POLICY ASSESSMENT NOTE: NORTH/SOUTH SHARED PEDESTRIAN CYCLE ROUTE**53-55 VASTERN ROAD, READING (RBC PLANNING APPLICATION REFERENCE 200188)****1. Introduction**

1.1. Following a meeting held on Monday 14th September 2020, with Jonathan Markwell (Case Officer – Reading Borough Council) and Darren Cook (Highways Officer – Reading Borough Council), some concerns were noted in relation to the proposed north/south shared pedestrian/cycle route, which extends through the above site. These concerns raised by RBC are summarised as follows:

Figure 5.3: Station/River Major Opportunity Area Strategy

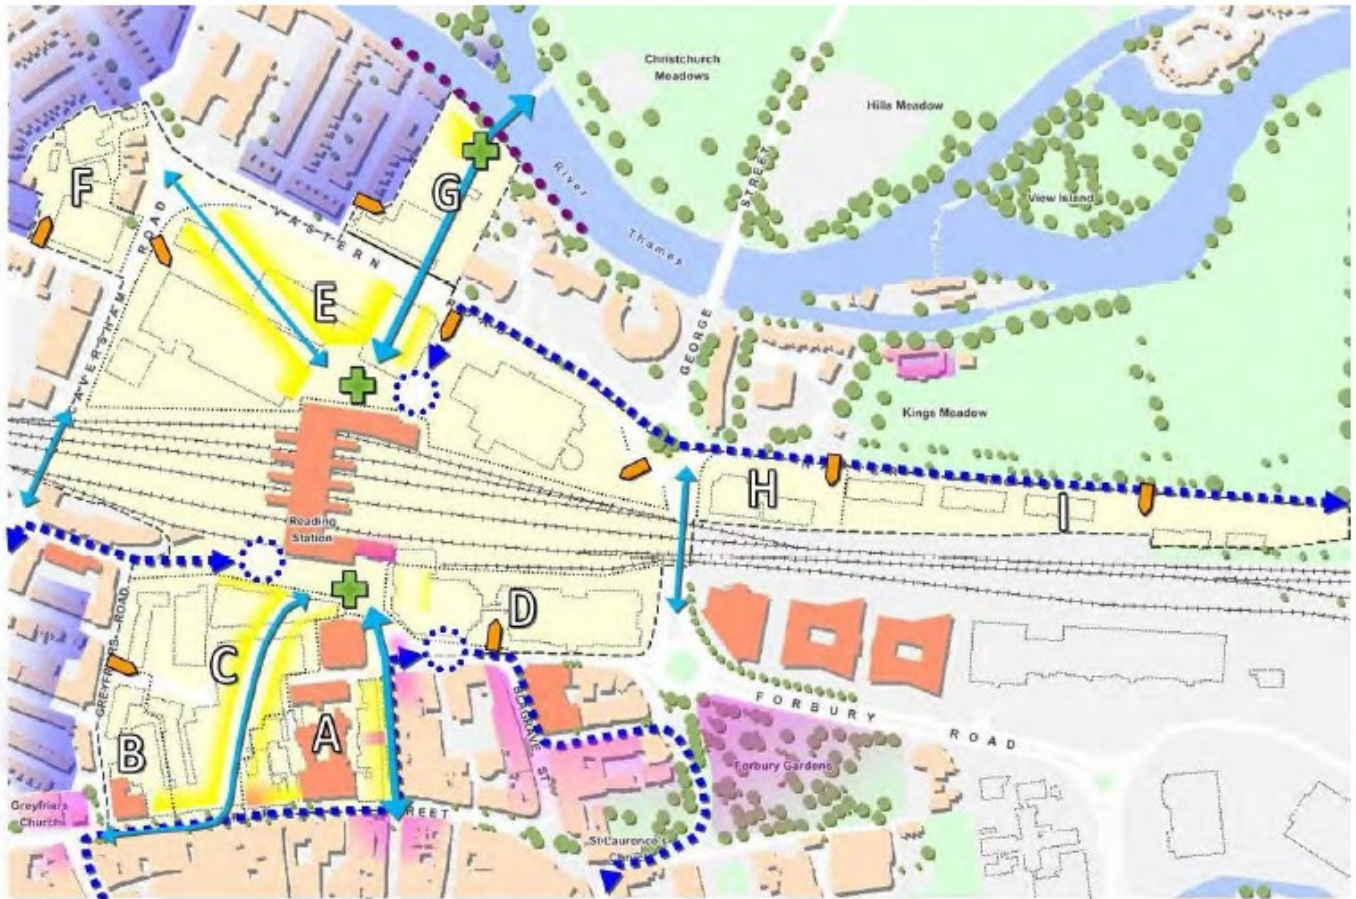
2.6. Figure 5.3 illustrates the Station/River Major Opportunity Area. The Strategy identifies a key movement corridor through the Site, as well as a desired new area of open space and 'activation' area, as shown below. It is noted that paragraph 5.4.6 of the Local Plan states:

In particular, on the Riverside site (CR11g), achieving this north-south link is the main priority for the site, and this should be given substantial weight in development management.

- 4.5. Policy CR2 requires the provision of well-designed public spaces that provide suitable functions and interest, sense of place and safe and convenient linkages to adjoining areas. Figure 5.3 identifies a desire for new open space and 'activation' within the Site. The proposed route has been designed as an integral part of the development, providing a convenient and naturally surveilled route linking Vastern Road to the River Thames and Caversham beyond. A high-quality podium courtyard with outdoor social seating and a café spill out area is provided, creating a suitable function for the riverside open space with all the buildings within this area facing on to the proposed route. In this regard, the proposed route is consistent with Policy CR2 as well as Figure 5.3.

4.12. RSAF paragraph 5.9 requires the provision of direct pedestrian route from the Station, through the Site to the River. As illustrated within figure 5.3 of the Local Plan (see paragraph 2.7 above), this is clearly a macro level aspiration for a key movement corridor, to connect the different areas of central Reading with the northern areas. It is important however to understand the meaning of 'direct', which it is considered to mean the shortest and fastest way from one place to another, as noted within the Government Transport Note (see paragraph 2.19 above). For completeness, reference to 'directness' meaning 'straight' has not been found within any of the key policies or guidance. Regardless, it is considered that the route has been designed to be as straight as possible given site constraints.

Figure 4.1 Station/River Major Opportunity Area Strategy

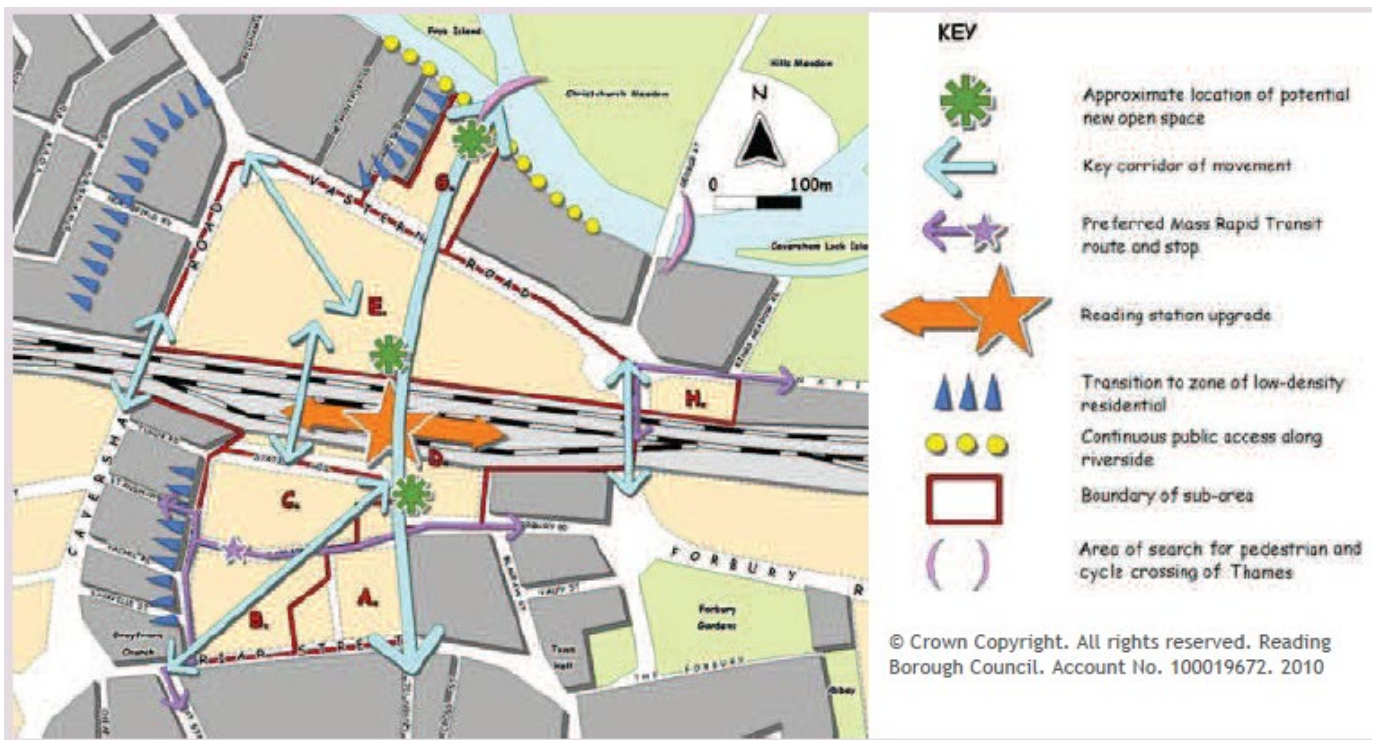
2.10. Figure 4.1 of the RSAF, informed by a now outdated policy context, illustrates the strategy for the area. It includes a strategic-scale key corridor of movement which passes through the Site, as shown below:
